Access Compliance Report Public Rights-of-Way (Curb Ramps)

Main Street: 17TH_ST Cross Street: LAMBETH_WAY Location: SE

ADA ID: RPRK220124110534 Ramp Type: Type 4 - Parallel Initial Pass/Fail: Fail Overall Compliance: No Severity Score: 15

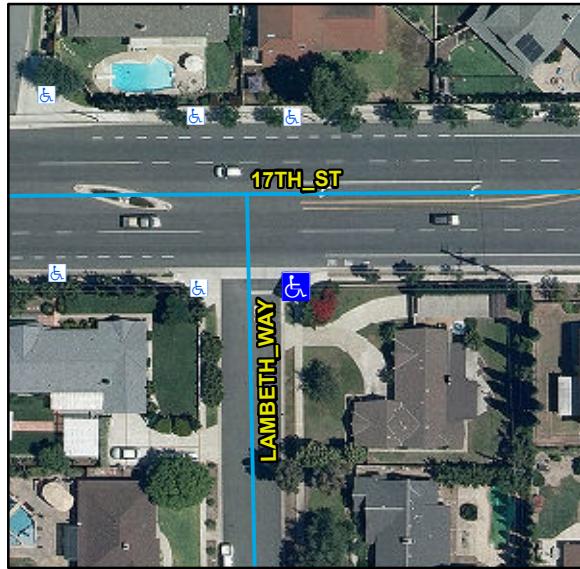
Compliance	Description	Data	Compliance	Description	Data
N/A	Ramp Length LT (in)	84	N/A	Ramp Length RT (in)	96
Yes	Ramp Width LT (in)	107	Yes	Ramp Width RT (in)	107
Yes	Ramp Run Slope LT (%)	6.3	Yes	Ramp Run Slope RT (%)	4.9
No	Ramp Cross Slope LT (%)	6.6	No	Ramp Cross Slope RT (%)	4.5
N/A	Landing Present	N/A	N/A	DWS Provided	N/A
N/A	Landing Length (in)	N/A	N/A	DWS Contrast	N/A
N/A	Landing Width (in)	N/A	N/A	DWS Length (in)	N/A
N/A	Landing Run Slope (%)	N/A	N/A	DWS Full Width	N/A
N/A	Landing Cross Slope (%)	N/A		DWS Offset Type	N/A
N/A	Landing Movement Obstructed?	N/A	N/A	DWS Offset Left (in)	N/A
	Landing Movement Type	N/A	N/A	DWS Offset Right (in)	N/A
N/A	Landing Shared	N/A			
N/A	Clear Space	Yes			
N/A	Clear Space To Crosswalk (in)	N/A			
N/A	Marked Crosswalk 1	No	N/A	Marked Crosswalk 2	No
	Crossing 1 Direction	N		Crossing 2 Direction	W
	Marked Crosswalk 1 Width (in)	N/A		Marked Crosswalk 2 Width (in)	N/A

Remove & Replace Curb Ramp With Two New Directional Ramps or Equivalent.

R304.5.3, STD 1115
